YASKAWA

Release Notes for MPiec controller firmware

Release 2.5.3 build 1

Patch for MP2300Siec and MP2310iec only

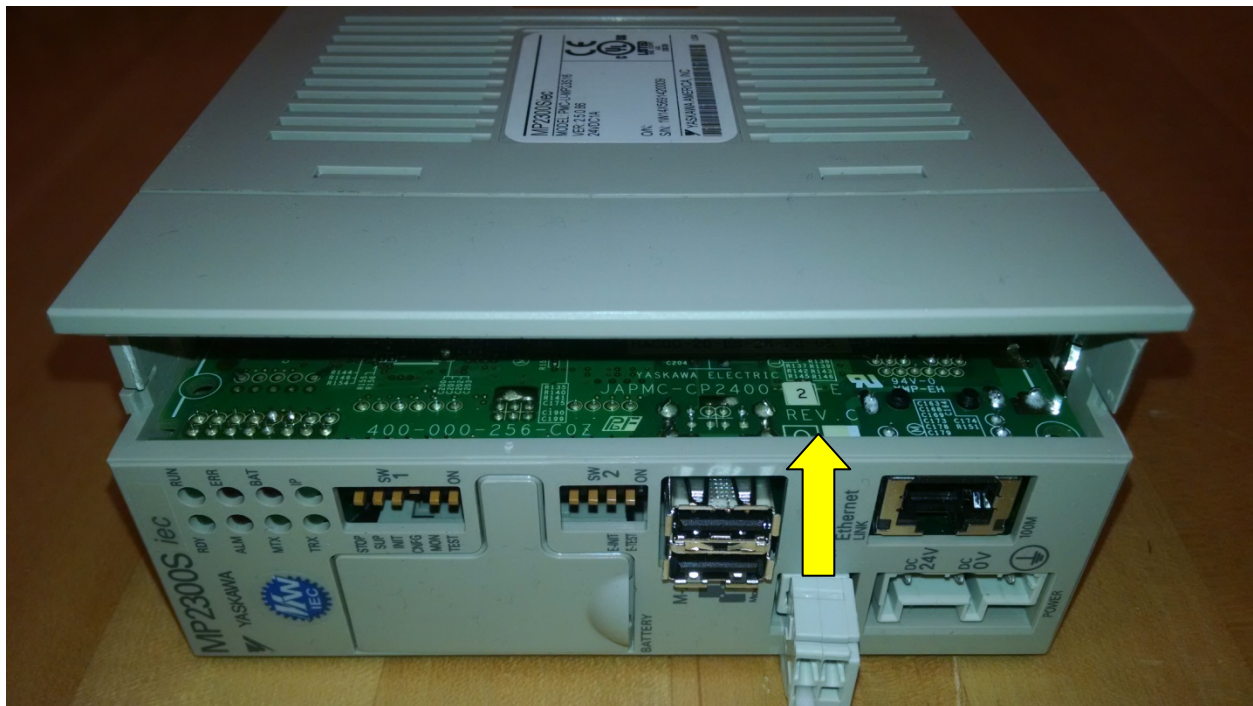
2.5.3.1 is a special release for the MP2300Siec and MP2310iec controllers with rev C hardware. To determine if the controller has rev C hardware, look at the silkscreen of the CPU board as shown below. If your machine was designed and tested using firmware 2.5.x firmware, Yaskawa recommends updating to 2.5.3.1 as the only difference is a change to eliminate the chance for impaired Ethernet performance as noted below.
